Product Change Notification - SYST-14YTT0745

ERRATA - dsPIC33EVXXXGM00X/10X Family Silicon Errata and Data Sheet Clarification

Description of Change: 1) Addition of silicon die revision AD. 2) Added data sheet clarification 2 (Electrical Characteristics)

dsPIC33EVXXXGM00X/10X Family Silicon Errata and Data Sheet Clarification

FIGURE 1:

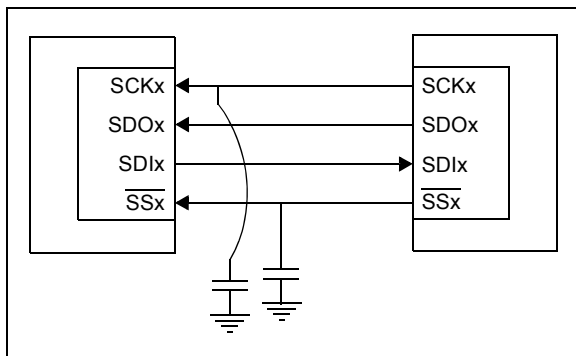
When the SPIx module is configured in SPIx Slave mode (MSTEN bit (SPIxCON1[5]) = 0), the frame slave (FRMEN bit (SPIxCON2[15]) = 1) and the SPIFSD bit (SPIxCON2[14] = 1), in Standard Buffer mode with the Clock Polarity Select bit, CKP = 0, the data is not transmitted in both 8-bit and 16-bit mode, but the data is being received correctly.

Adding a capacitance on the signal, as shown in Figure 1, will help the data to be received properly.

FIGURE 2: TIMING DIAGRAMS FOR CENTER-ALIGNED AND EDGE-ALIGNED MODES

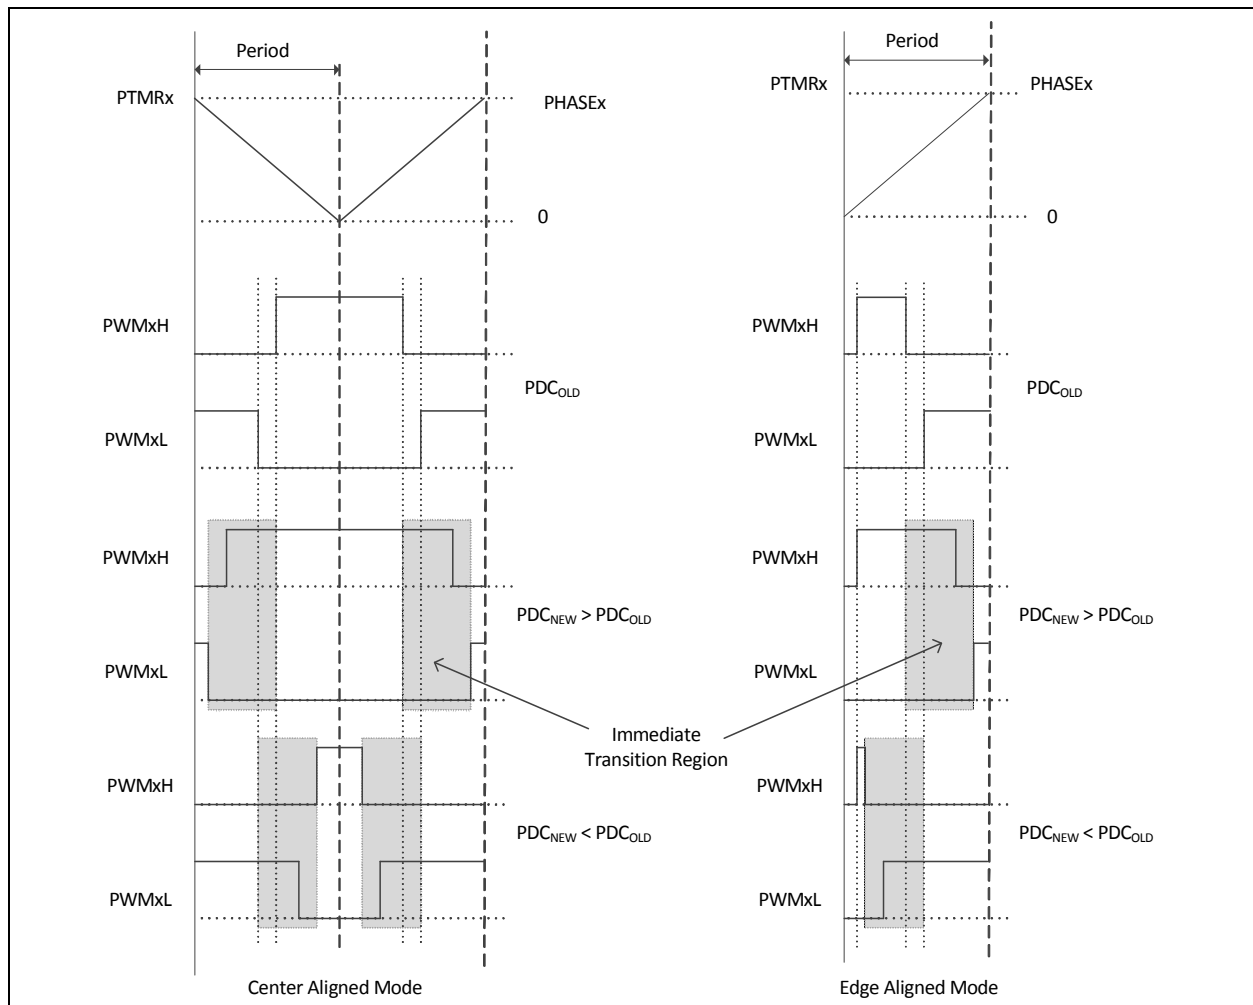
The PWM generator may not assert dead time on the edges of transitions. This has been observed when all of the following conditions are present:

In [Figure 2](#), if the duty cycle write occurred in the shaded box, then PWMxH and PWMxL will make an immediate transition without dead time.

However, in most applications, the duty cycle update timing can be controlled using the TRIGx trigger or Special Event Trigger, such that the above mentioned conditions are avoided altogether.

FIGURE 3: ILLUSTRATION OF 1 T_{osc} GLITCH WHEN PWM OVERRIDE IS TURNED OFF

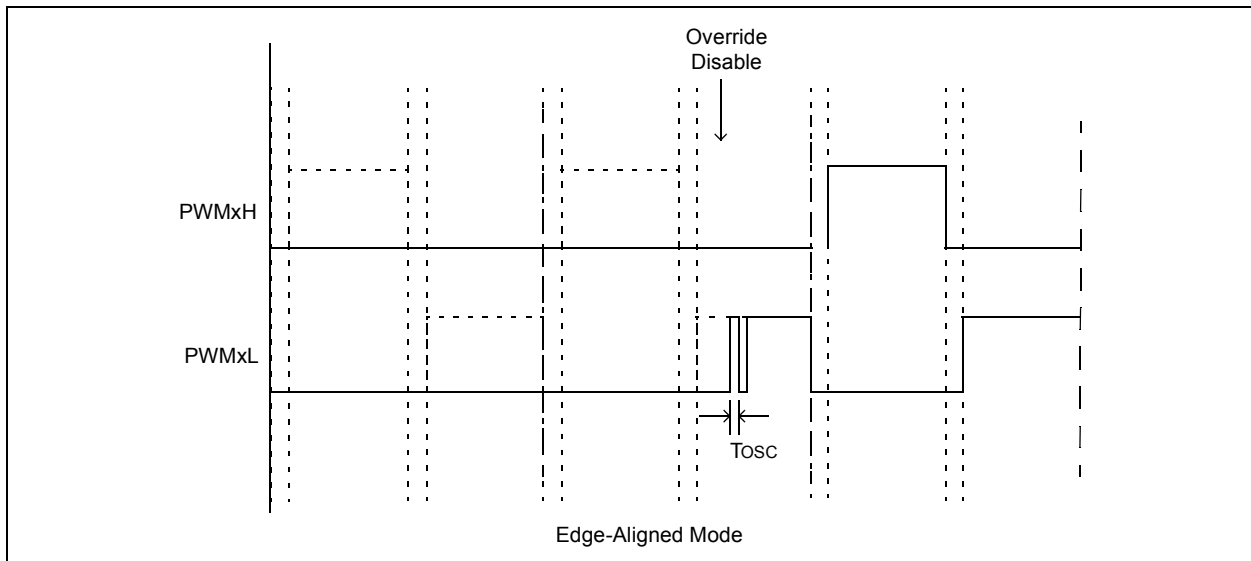
In Complementary mode after the PWM module is enabled (PTEN = 1), if the PWM override is turned off, a one T_{osc} glitch will be present on the rising edge of either the PWMxH or PWMxL pins, whichever occurs first, as shown in Figure 3.

The glitch will be present on PWMxH/PWMxL every time the override state is changed from override enabled to override disabled. The width of this glitch is equal to one T_{osc} when PCLKDIV[2:0] (PTCON2[2:0]) = 000. Increasing the PWMx input clock prescaler setting will increase the width of the glitch accordingly.

FIGURE 4:

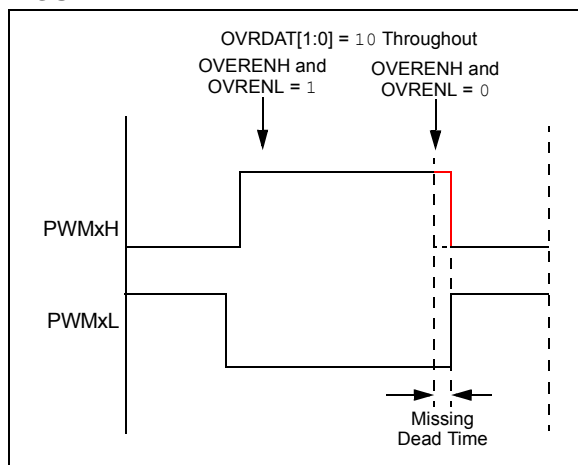
In Complementary Output mode, the expected dead time between transitions of the PWMxH and PWMxL outputs may not be asserted when the following occurs:

- Output override synchronization is configured to occur on the CPU clock boundary (IOCONx[0] = 0);
- Both PWMxH and PWMxL overrides are enabled prior to the event (OVRENH and OVRENL are both '1'), and
- Both overrides are disabled (OVRENH and OVRENL are both '0') at the instant the dead time should be asserted (Figure 4). This has been observed in both Center-Aligned and Edge-Aligned modes.

FIGURE 5:

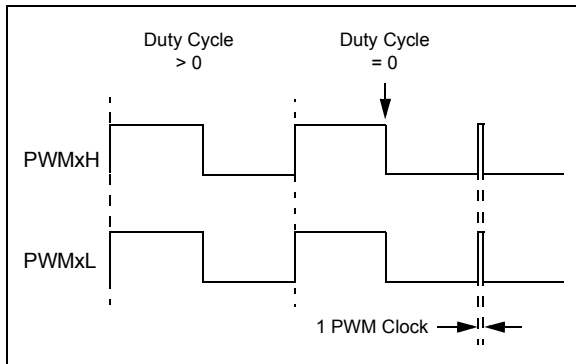
In the Redundant Output mode (IOCONx[11:10] = 10) and Push-Pull Output mode (IOCONx[11:10] = 01) with Immediate Update disabled (PWMCONx[0] = 0), when the Duty Cycle register is updated from a non-zero value to zero, a glitch pulse of a width equal to one PWM clock will appear at the next PWM period boundary, as shown in Figure 5, for the Redundant Output mode. Here, the Duty Cycle register refers to the PDCx register if PWMCONx[8] = 0 or the MDC register if PWMCONx[8] = 1.

If the application requires a zero duty cycle output, there are two possible work around methods:

1. Use the PWM override feature to override the PWM output to a low state instead of writing to the Duty Cycle register. In order to switch back to a non-zero duty cycle output, turn off the PWM override. The override-on and override-off events must be timed close to the PWM period boundary if the IOCONx register has been configured with IOCON[0] = 0 (i.e., output overrides via the OVDDAT[1:0] bits occur on the next CPU clock boundary).

2. Enable the Immediate Update (PWMCONx[0] = 1) while configuring the PWM module, i.e., before enabling the PWM module (PTCON[15] = 1). With Immediate Update enabled, writes to the Duty Cycle register can have an immediate effect on the PWM output. Hence, duty cycle write operations must be timed close to the PWM period boundary in order to avoid distortions in the PWM output.

FIGURE 6:

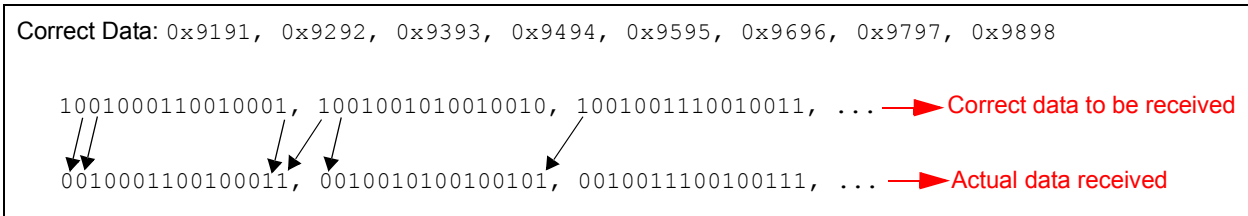
Received data of the SPI is sampled one clock cycle late for the following conditions:

For example, the correct data that should be received is 0x9191, 0x9292, 0x9393, 0x9494, 0x9595, 0x9696, 0x9797, 0x9898, but the actual data received is 0x2323, 0x2525, 0x2727, 0x2929, 0x2B2B, 0x2D2D, 0x2F2F, 0x3130 (Figure 6).

FIGURE 7: SIMPLIFIED BEHAVIOR

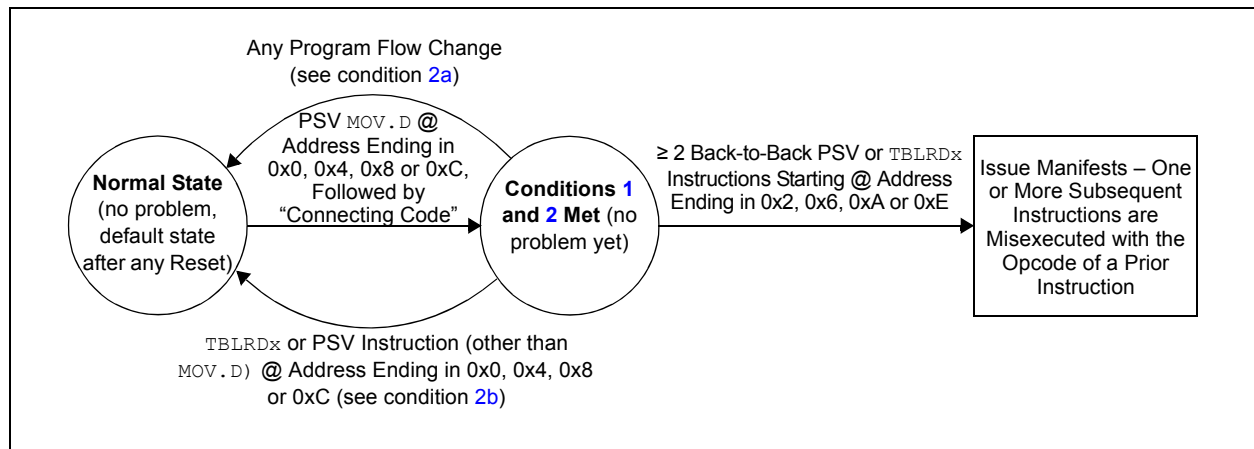
3.	≥ 2 back-to-back PSV or <code>TBLRDx</code> instructions are executed (following the code of condition 2), where the first of the back-to-back instructions is located at an address ending in 0x2, 0x6, 0xA or 0xE.

[Figure 7](#) provides an example of the effective behavior.

1. All instances of PSV `MOV.D` can be replaced with two PSV `MOV` instructions instead. Non-PSV `MOV.D` instructions acting on RAM/SFRs do not need to be modified; or
2. If not already present, a program flow change instruction (such as `BRA $+2`) can be inserted above back-to-back data Flash read sequences; or
3. Back-to-back data Flash read instruction sequences can be broken up by inserting a non-Flash read instruction (such as a `NOP`), in between the Flash read instructions; or
4. The alignment of the code can be shifted to avoid the required opcode location addresses.
